HYDROGRAPHIC TITLE SHEET

H-9724

Locality HILLER COVE TO INDIAN NECK

DESCRIPTIVE REPORT
TO ACCOMPANY SURVEY

Marsh

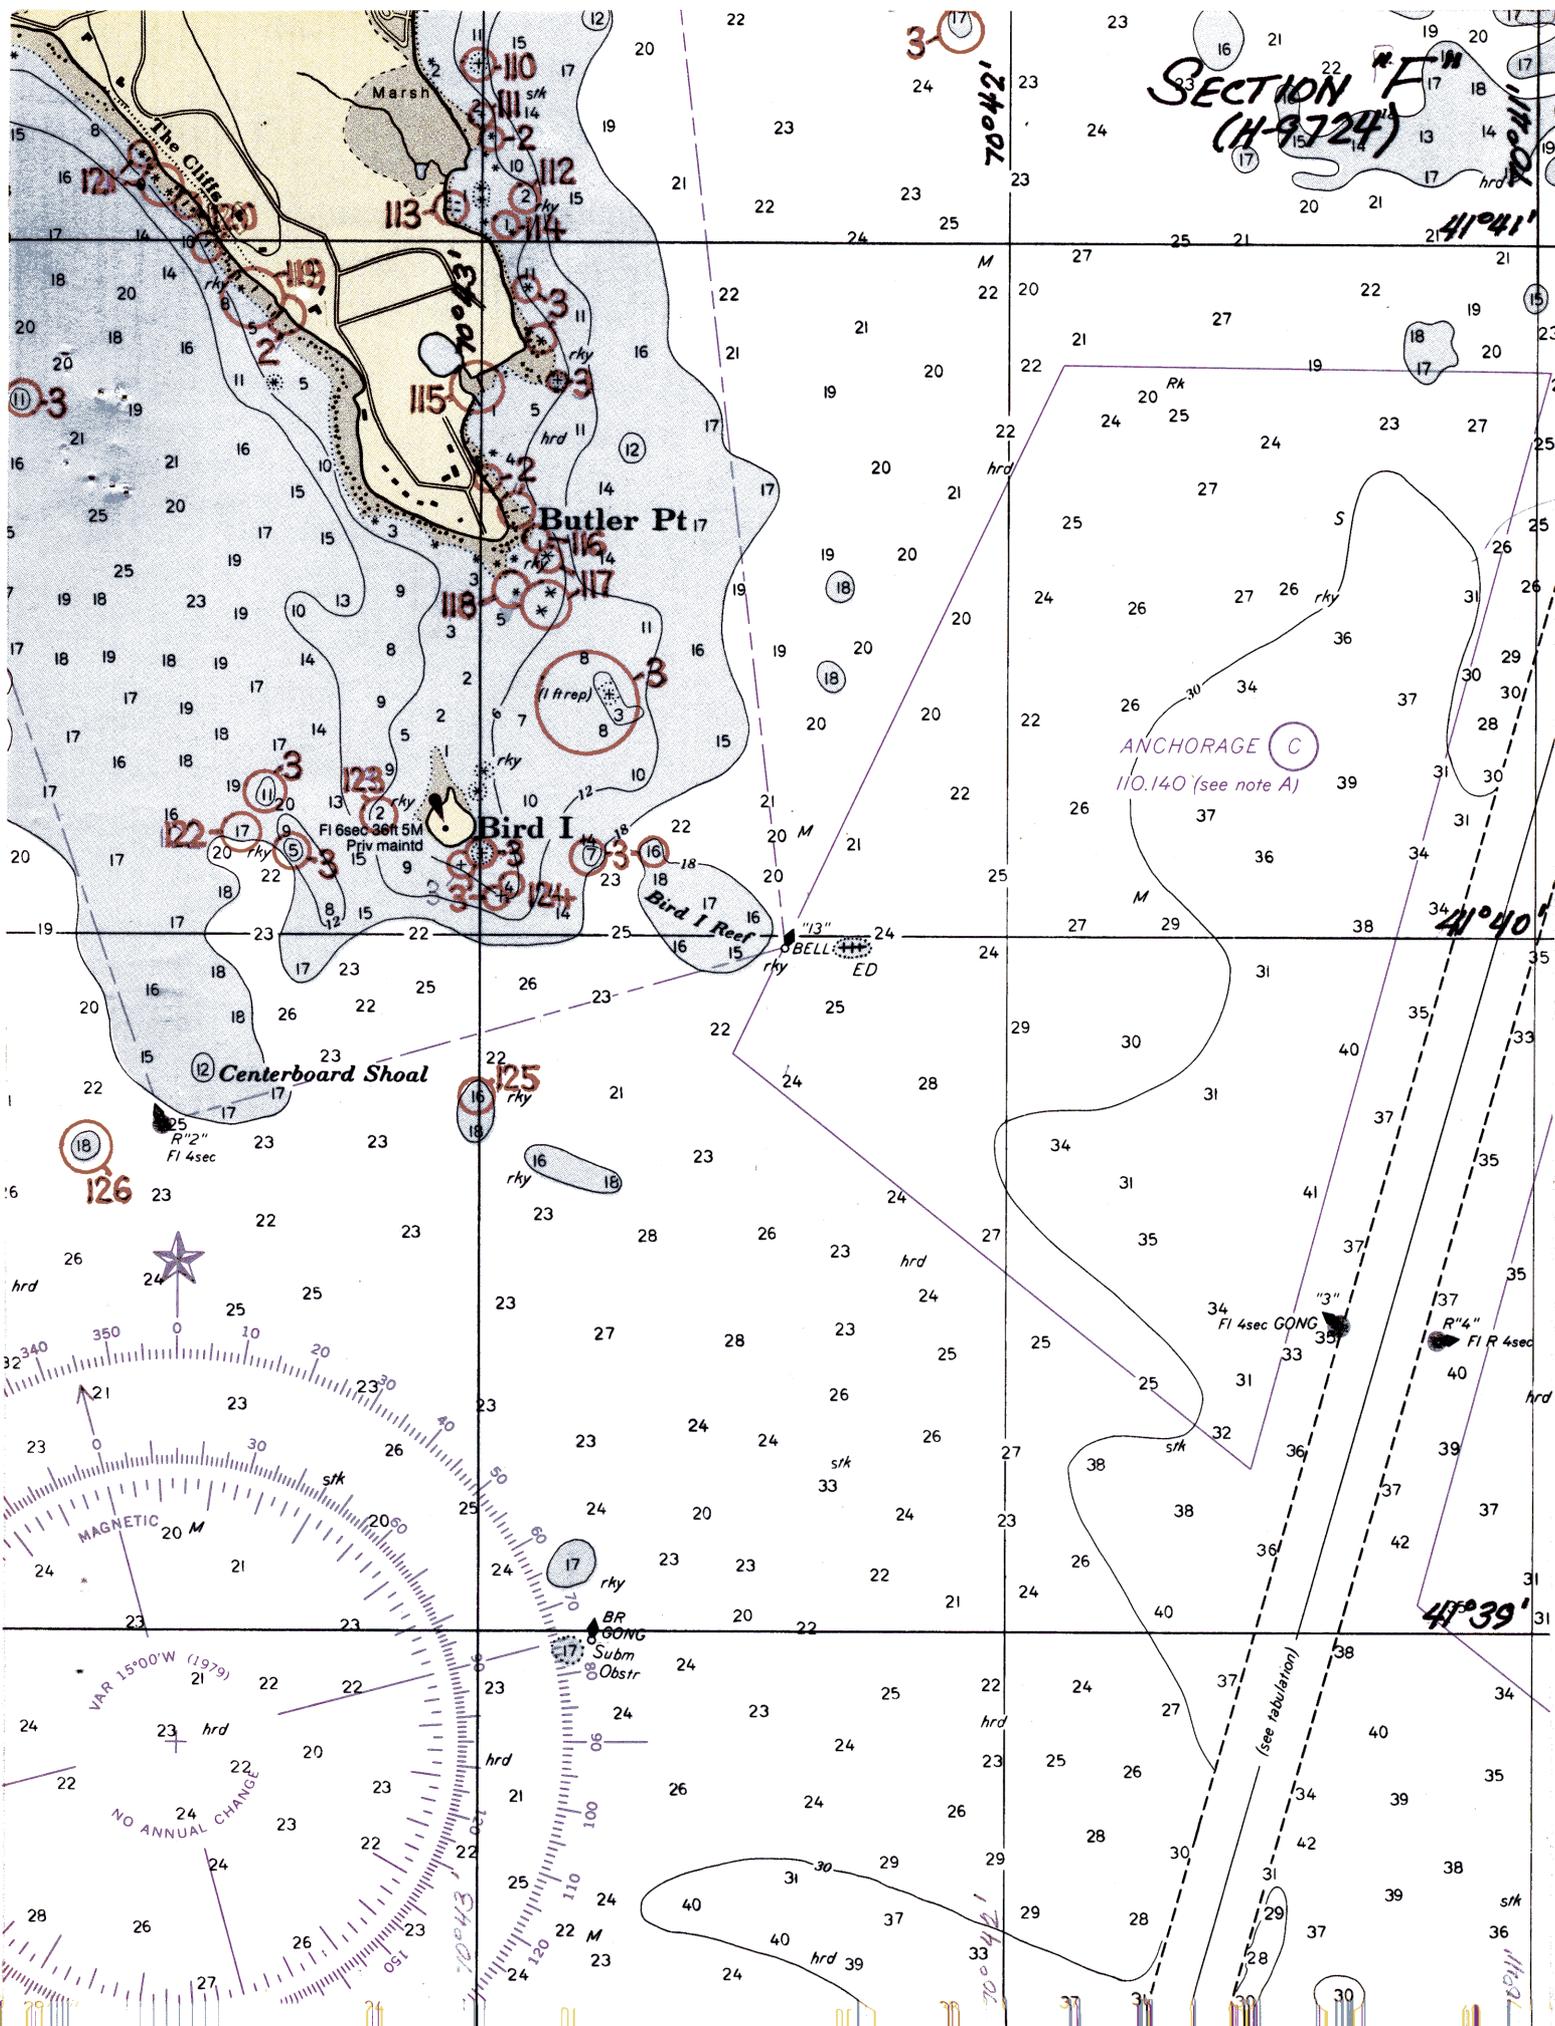
24. A comparison between the present survey and Chart 13236, 21st Edition, dated June 27, 1981, was made during quality control inspection in order to provide additional guidance to the nautical chart compiler. Many charted items have not heretofore been addressed. The attached six chart sections contain numbered items cross-referenced to the following numbered recommendations:

(9) The geographic name "Quasuet Pt." is mistakenly charted as "Quasuet P"--revise the new chart edition accordingly.

- (20) Pier is charted from a miscellaneous source. Shoreline change suggests cultural improvements in this area. Recommend expunging the charted pier.

- (25) The delineation of the "L" pier, charted from a miscellaneous source, is in conflict with the delineation shown on TP-00764 (1974-79). The Class I map delineation is considered questionable. A charting resolution is deferred to the chart compiler.

(60a) A 13-foot sounding or soundings of 1 and 3 feet is/are charted from a miscellaneous source. Expunge the questionable item and chart depths in the area as shown on the present survey.

(74) The pier and questionable marks connected to the shoreline are charted from a miscellaneous source. Chart the area as shown on the present survey.

(84 and 85) One-foot soundings charted from H-2272 (1896) are labeled "rock" on their source. Rocks awash, covered 1 foot at MLW, were carried forward to the smooth sheet. Chart the appropriate symbol instead of the 1-foot soundings.

(86) The 8-foot sounding, charted from H-2272 (1896), is labeled "rock" on the original source. The 8-foot sounding with "Rk" appended was carried forward to the present survey and should be charted as shown on the smooth sheet.

(88) The 2-foot sounding charted from H-2272 (1896) is labeled "rock" on the original source. This item was carried forward to the smooth sheet as a 2-foot sounding with "Rk" appended and should be charted as such.

- (100) The 1-foot sounding, charted from H-2272 (1896), is identified on the original source as a rock. A rock covered 1 foot at MLW was carried forward to the smooth sheet. Chart the appropriate rock symbol.

- (101) The geographic name "Seal Rocks" is charted in vertical letters denoting bare rocks. There are no bare rocks on the present survey in this area. Revise the charted letters from vertical to slanted.

- (104) Revise the charted double line delineation of this item to a single line delineation as shown on the present survey.
- (105) The 3-foot sounding, charted from H-2272 (1896), is identified as a sunken rock on the source. A 3-foot sounding with "Rk" appended was carried forward to the smooth sheet and should be charted as such.

- (108) Ruins originate with a pier on T-2215 (1895). The charted ruins are not noted in the present survey records and fall within a foul area delineated on the smooth sheet. A charting resolution is deferred to the chart compiler.

- (112) The 2-foot sounding, charted from H-2272 (1896), is identified on the original source as a rock. The 2-foot sounding with "Rk" appended was carried forward to the smooth sheet and should be charted as shown on the smooth sheet.

- (113) Chart the locations of the groins as shown on the present survey.
- (114) The 1-foot sounding, charted from H-2272 (1896), is identified as a rock awash covered 1 foot at MLW on the original source. This rock awash was not shown on the smooth sheet since it falls within the limits of a foul area delineated on the smooth sheet.

- (121) Chart locations of rocks awash in this area as shown on the present survey.
- (122 through 124) The 17-, 2-, and 4-foot soundings charted from H-2272 (1896) are identified on the original source as submerged rocks. The three soundings with "Rk" appended to each were carried forward to the smooth sheet and should be charted as shown on the smooth sheet.

- (125) The 16-foot sounding, charted from H-3391 (1912-14) WD, is identified on the original source as a submerged boulder. The 16-foot sounding with "Bld" appended was carried forward to the smooth sheet and should be charted as shown on the smooth sheet.
